CP-200901488
Log # TXNB-09055

October 19, 2009

SUBJECT: COMANCHE PEAK NUCLEAR POWER PLANT, UNITS 3 AND 4
DOCKET NUMBERS 52-034 AND 52-035
RESPONSE TO REQUESTS FOR ADDITIONAL INFORMATION NO. 2749,
2751, 2758, 2760, 2795, 2970, 2971, 3033, 3225, 3398, 3401, 3402, 3556, AND 3557

FIGURE 11.04-1-01: SKETCH OF DEWATERING AREA

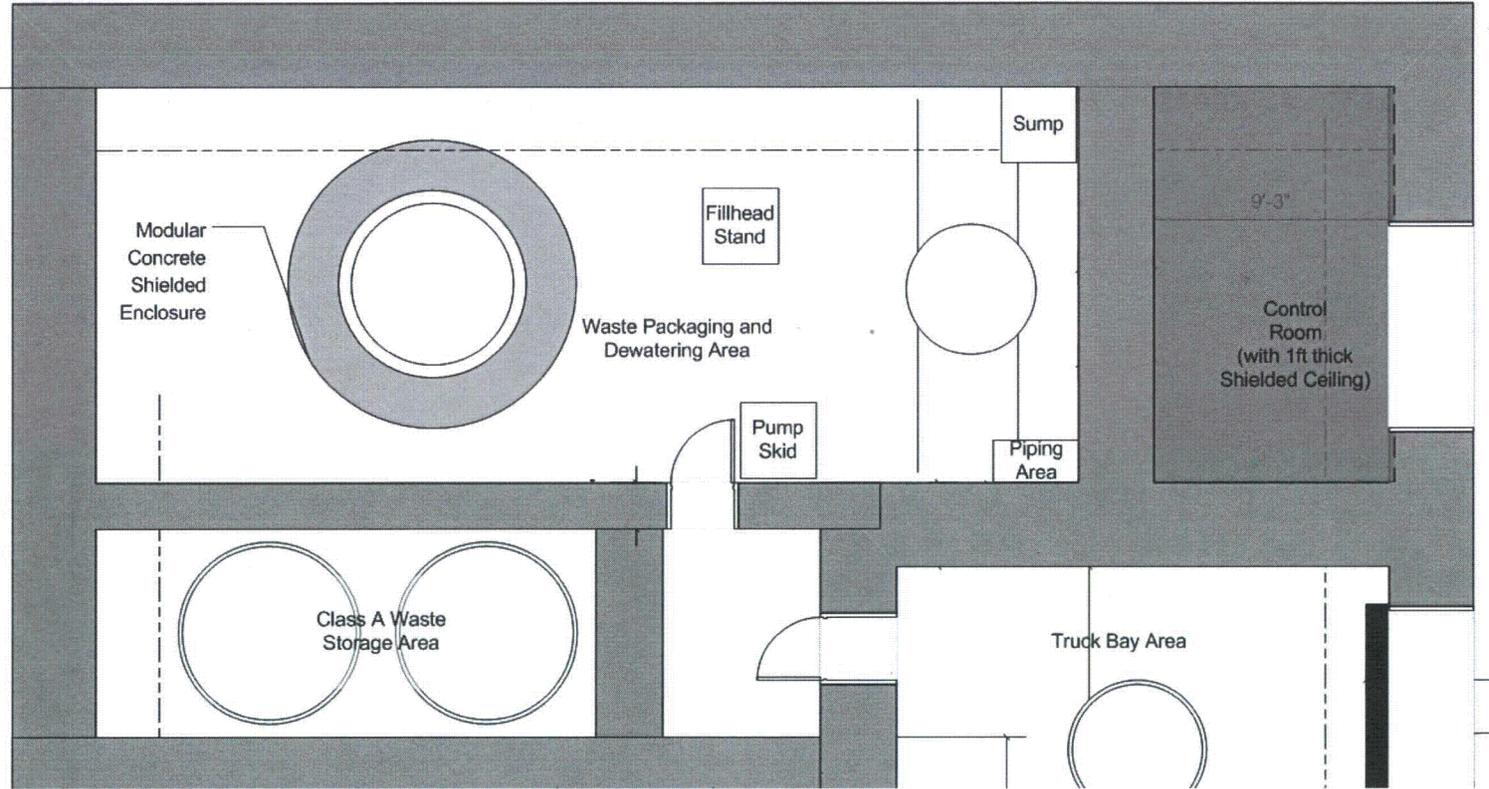
With respect to the mobile de-watering system, Luminant is requested to include in the FSAR, discussion of how contracted mobile de-watering system would meet the design requirements of Regulatory Guide (RG) 1.143, "Design Guidance for Radioactive Waste Management Systems, Structures, and Components Installed in Light-Water-Cooled Nuclear Power Plants," Revision 2, November 2001. Additionally, Luminant is requested to include in the FSAR discussions of capability to permit inspection, testing of components, shielding, and operational procedures for contracted mobile systems.

The lease or purchase document for the mobile de-watering system will specify the applicable regulatory criteria, as well as testing, inspection, interfacing requirements, and operating procedures (including Luminant oversight of vendor personnel). This requirement is added in Subsection 11.4.4.5.

As described in DCD Subsection 11.4.2.2.1, the dewatering subsystem is located in a shielded cubicle near the storage area. Access port and shield doors are provided to assist operation, and to permit inspection and testing of components. A sketch (Figure 11.04-1-01) indicating the location and the access port is attached to illustrate the design concept.

Figure 11.5-201 Typical Process In-Line Radiation Monitor Schematic

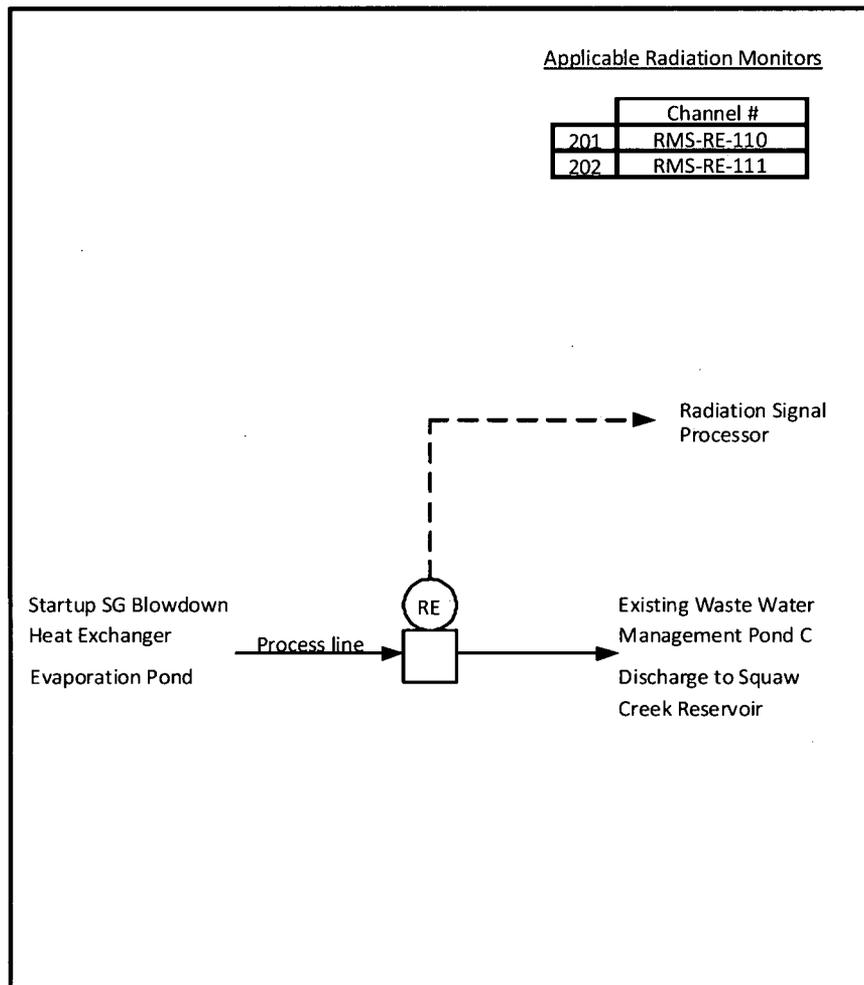
3. Revise CP COL 10.4(2) to remove the statement that details of the SGBDS radiation monitor will be developed during the detail design phase.
4. Explain the bypass around the SGBDS radiation monitor in Figure 10.4.8-201.

See attached marked-up FSAR Draft Revision 1 pages 10.4-7, 11.5-1, 11.5-2, 11.5-4, Table 1.5-201 (page 11.5-5), Figure 11.5-201, and COLA Part 10 page 34.

The startup steam generator blowdown heat exchanger downstream radiation monitor is a gamma detector; the detection range and other details are summarized in Table 11.5-201, item number 201. A process schematic for this monitor is shown in Figure 11.5-201.

The evaporation pond discharge radiation monitor is a gamma detector; the detection range and other details are summarized in Table 11.5-202, item number 202. A process schematic for this monitor is shown in Figure 11.5-201.
